LINE	QUANTITY	UOP	CAT NO.	ITEM NUMBER	UNIT PRICE	AMOUNT
ADDENDUM NO. 1						
THIS ADDENDUM IS ISSUED TO:						
1) PROVIDE THE ATTACHED ADDENDUM: ADDITIONAL TERMS & CONDITIONS.						
2) PROVIDE THE ATTACHED TECHNICAL QUESTIONS & ANSWERS.						
3) PROVIDE THE ATTACHED REVISED TECHNICAL SPECIFICATIONS.						
4) PROVIDE THE ATTACHED MANDATORY PRE-BID SIGN IN SHEETS.						
0001	1	JB		962-73		
RECLAMATION: RESTORATION OF WATER

Addendum Number: 01

- 1) Provide Addendum: Additional Terms and Conditions.
- 2) Provide technical question and answers.
- 3) Provide the revised technical specifications including 12 drawings.
- 4) Provide the attached Mandatory Pre-Bid Sign in Sheets.

**Addendum #1 - Questions During Pre-Bid Conference
For DEP 16124
Omega Mining Co., Inc.
Permit # D-79-82**

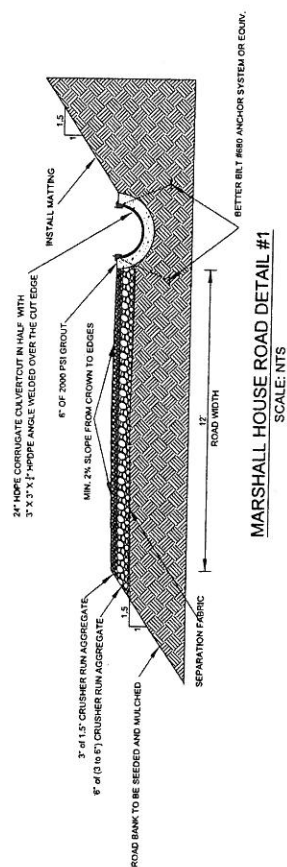
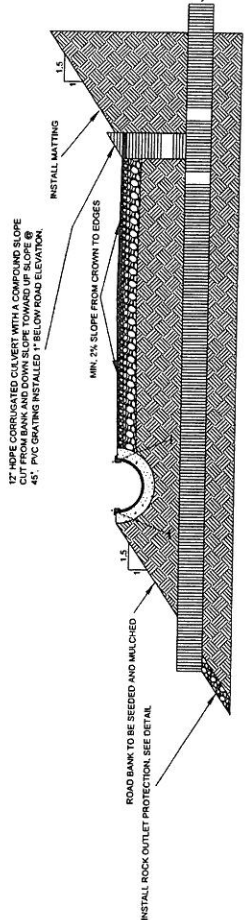
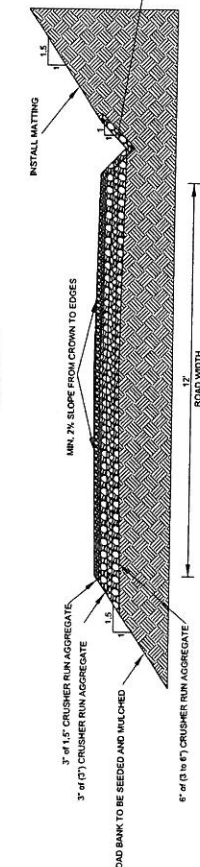
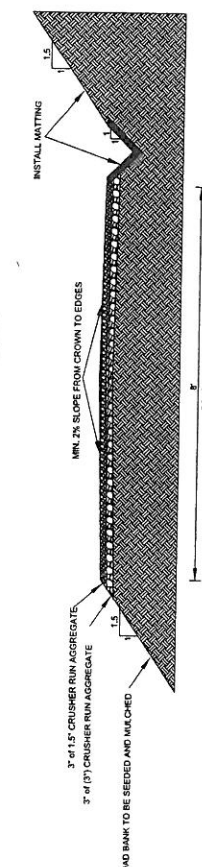
A. Yes
- 20.) Q. Will there be a final cap placed on the new road?
A. Yes, see Plan Sheet 68 for road details. The details provide all the layers of the road.
